UNITED STATES  
DEPARTMENT OF THE INTERIOR  
BUREAU OF LAND MANAGEMENT

8. Well Name and No.  
CEDAR CANYON 28 FEDERAL 19. API Well No.  
30-015-28723-00-S110. Field and Pool or Exploratory Area  
CEDAR CANYON11. County or Parish, State  
EDDY COUNTY, NM**SUBMIT IN TRIPLICATE - Other instructions on page 2**

\*\* BLM REVISED \*\* BLM REVISED \*\* BLM REVISED \*\* BLM REVISED \*\* BLM REVISED \*\*

OXY USA Inc. - Proposed  
 Cedar Canyon 28 Federal #001  
 API No. 30-015-28723

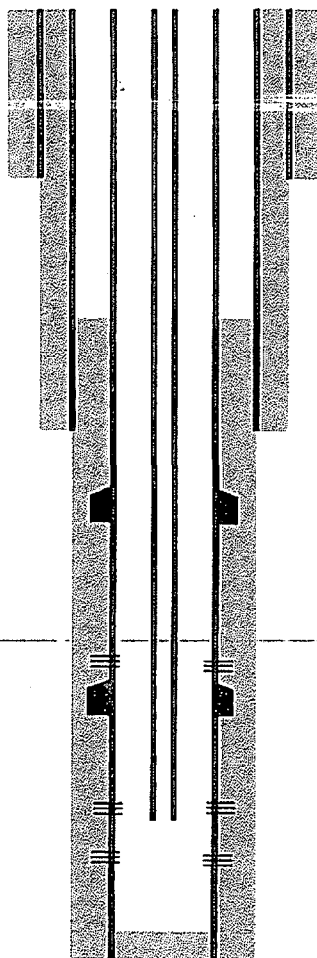
Perf @ 740' sqz 180sx to surface

Perf @ 1385' sqz 25sx from 1446' to 1346'  
 TALK

Spot 25 sx 2950' - 2820' (Delaware  
 TALK @ 2900')  
 2850' - 2618'

M&P 30sx from 2982' to 2648' - WOC - Tag  
 shoe @ 2800' / Base salt @ 2648'  
 M&P 25sx from 2840' to 2654' - WOC - Tag

4025' - 3885'  
 DV @ 3975'

CIBP @ 5141' w/ 35 sx to 4741' - WOC - Tag  
 Leak test CIBP

Spot 25 sx 6690' - 6520'  
 Bone springs @ 6640' TALK

- Spot 255x 6690' - 6520' Bonespring @ 6640' TAG  
1. POOH w/ production equipment and tubing.  
2. RIH & set CIBP @ 5141', M&P 35sx cmt to 4741' WOC-Tag Leak test CIBP  
3. M&P 25sx cmt from 3840' to 3554' WOC-Tag 4025' - 3885' DV @ 3975'  
4. M&P 30sx cmt from 2982' to 2648' WOC-Tag 2950' - 2820' (Delaware @ 2400')

Spt 30 sx 2800' - 2618' WOC TAG (Shoe @ 2800' / Base salt @ 2698')

5. Perf @ 1385' sqz 25sx cmt from 1446' to 1346' TAG

6. Perf @ 740' sqz 180sx cmt to Surface
